Subject: Interstate 4 from East of County Road 532 to Central Florida Parkway Value Engineering Study Recommendation Dispositions

FPID: 431456-1 & 242484-8

### Value Engineering Study Final Report

**RECOMMENDATION No. 9: Put a roundabout at Daryl Carter and Palm Parkway**

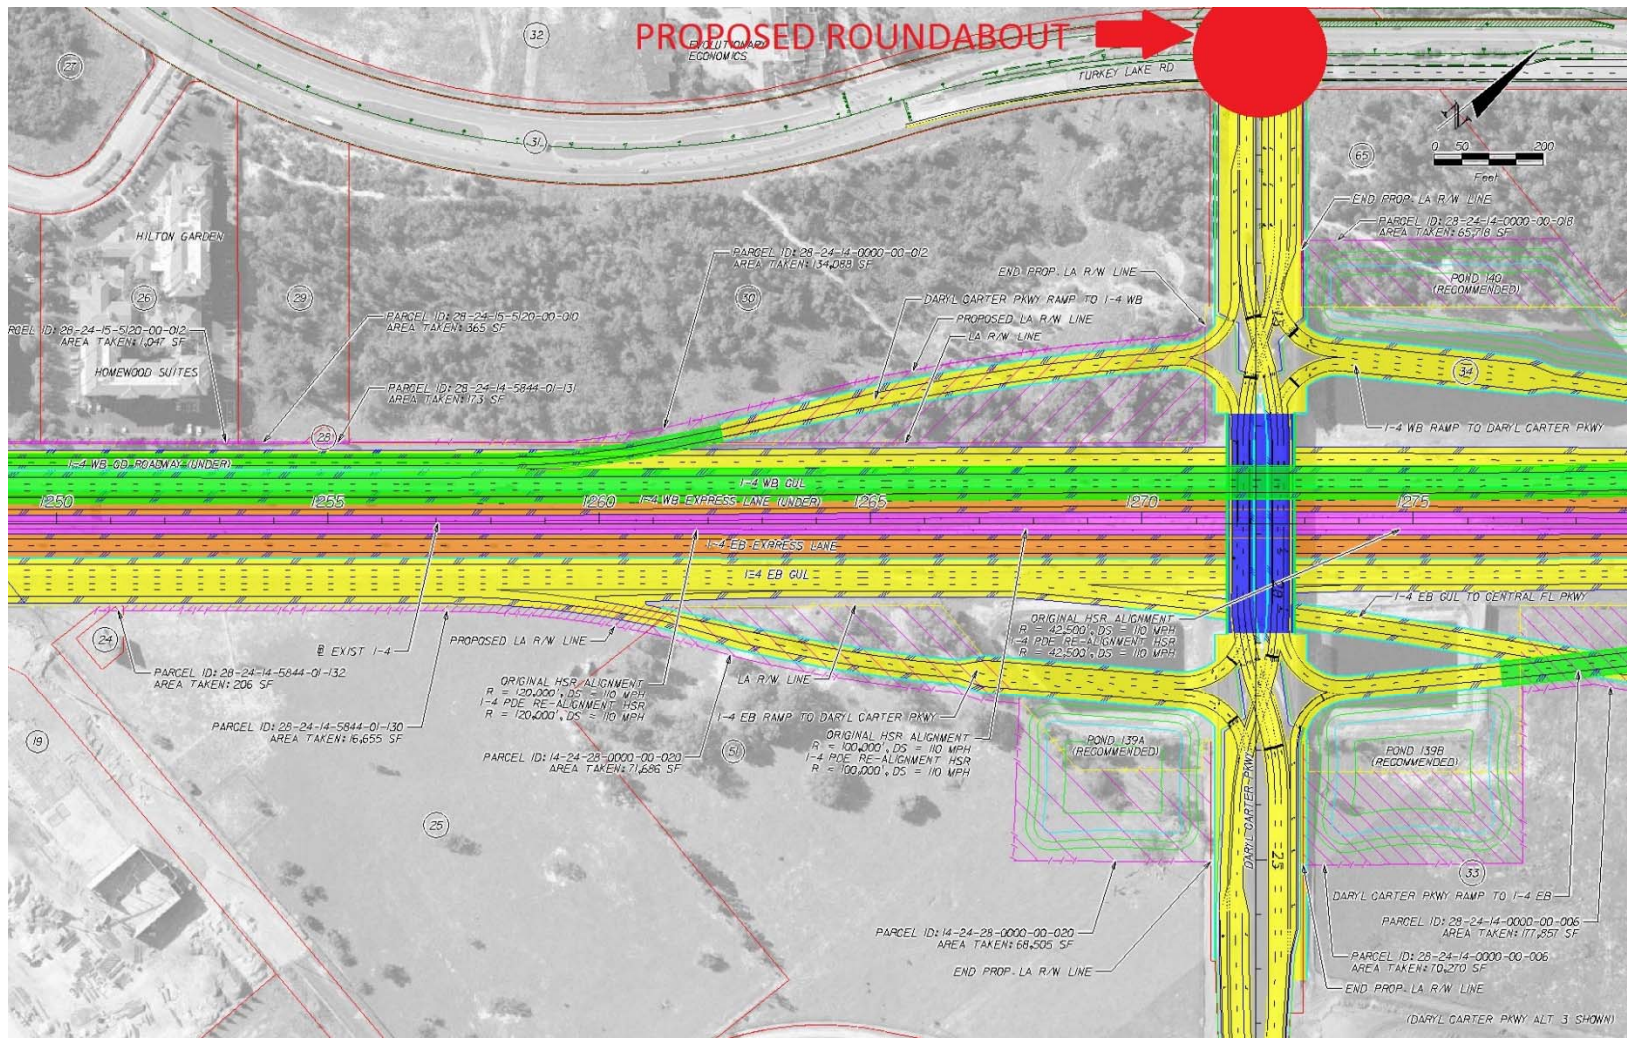
Recommendation 9: Put a roundabout at Daryl Carter and Palm Parkway.

The PD&E Documents show an existing signalized intersection for the above roadways. However, there is not a lot of queue length for the left-turning vehicles from westbound Daryl Carter Parkway to southbound Palm Parkway.

Not Accepted. For traffic operational purposes, roundabout at Daryl Carter and Palm Parkway is not recommended. Roundabout fails without the use of bypass lanes on all approaches.

**RECOMMENDATION No. 10: Eliminate the right turn movement for the westbound I-4 exit ramp to Daryl Carter and create a new I-4 to Palm Parkway exit and intersection 2,500 feet east of the Daryl Carter bridge**

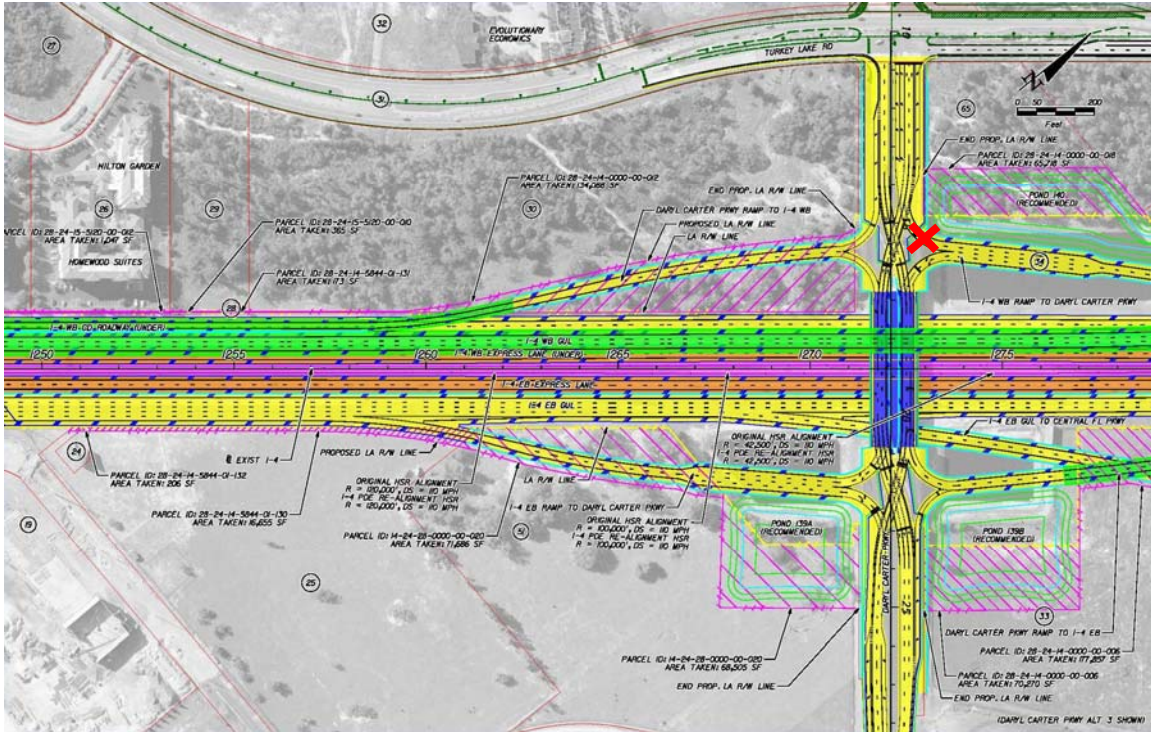
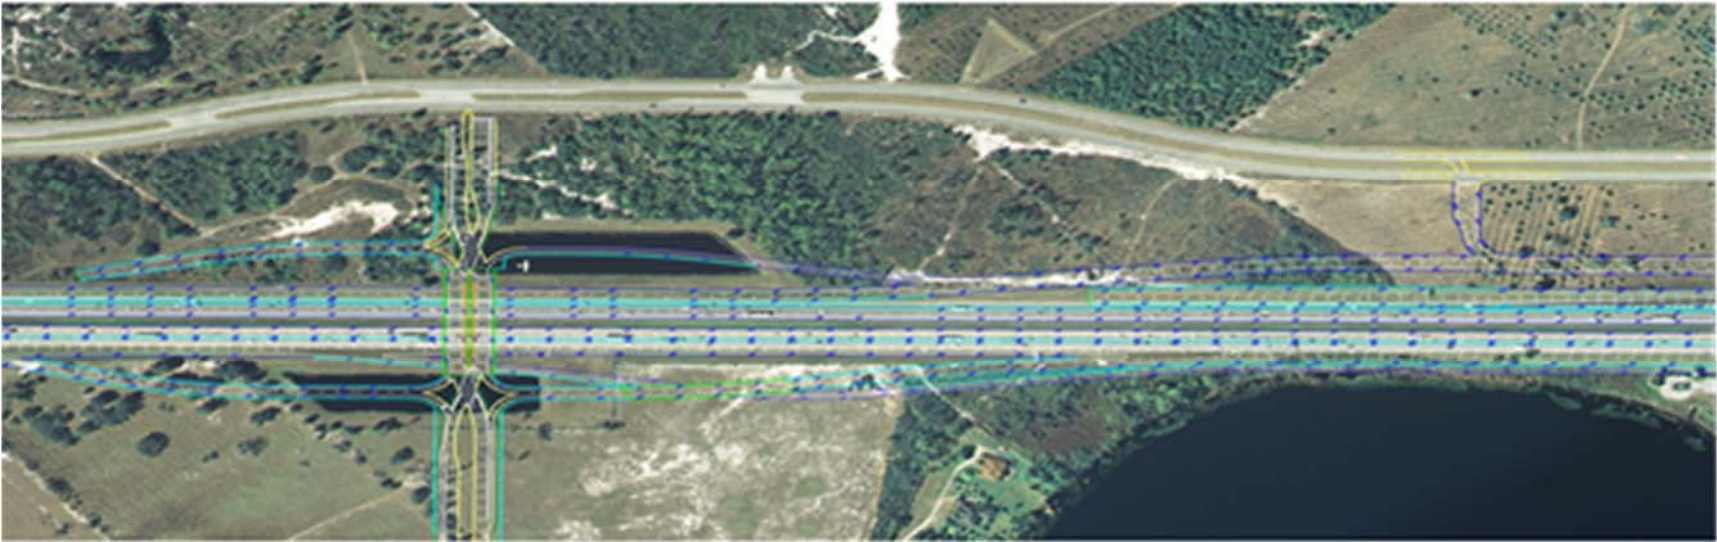
Recommendation 10: Eliminate the right turn movement for the westbound I-4 exit ramp to Daryl Carter and create a new I-4 to Palm Parkway exit and intersection 2,500 feet east of the Daryl Carter bridge.

**Proposed Alternative:** The PD&E Documents show traffic pattern extending to the Diverging Diamond at Daryl Carter Parkway

**VE Alternative:** Eliminate the right turn movement for the westbound I-4 exit ramp to Daryl Carter and create a new Palm Parkway exit and intersection 2,500 feet east of the Daryl Carter bridge to eliminate the traffic back-up from left turn to Palm Parkway.

Not Accepted. While queuing is a potential concern given the close proximity of Palm Parkway to the interchange, our analysis does not indicate any issues with the current PD&E configuration.

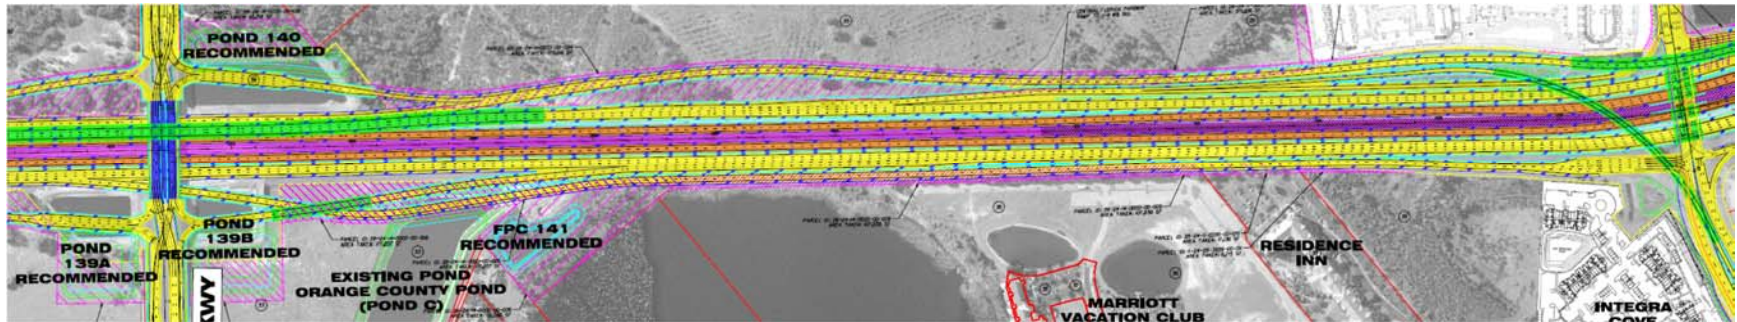
Recommendation 12: The exit ramp starting west of Daryl Carter Parkway could be shortened to approximately 1,300 ft. by exiting approximately 5,000 feet east of the Daryl Carter Parkway bridge.

The PD&E Documents show an I-4 eastbound Collector-Distributor road was added for the traffic to Central Florida Parkway. The Collector-Distributor road exits I-4 eastbound General Use Lanes at south of Daryl Carter Parkway Bridge, goes under the ramp bridge of Daryl Carter Parkway to I-4 eastbound and keeps parallel to I-4 eastbound General Use Lanes.

Not Accepted. This is not a viable option as this will create a heavy weave between Daryl Carter Pkwy eastbound on-ramp and Central Florida Parkway eastbound off-ramp.
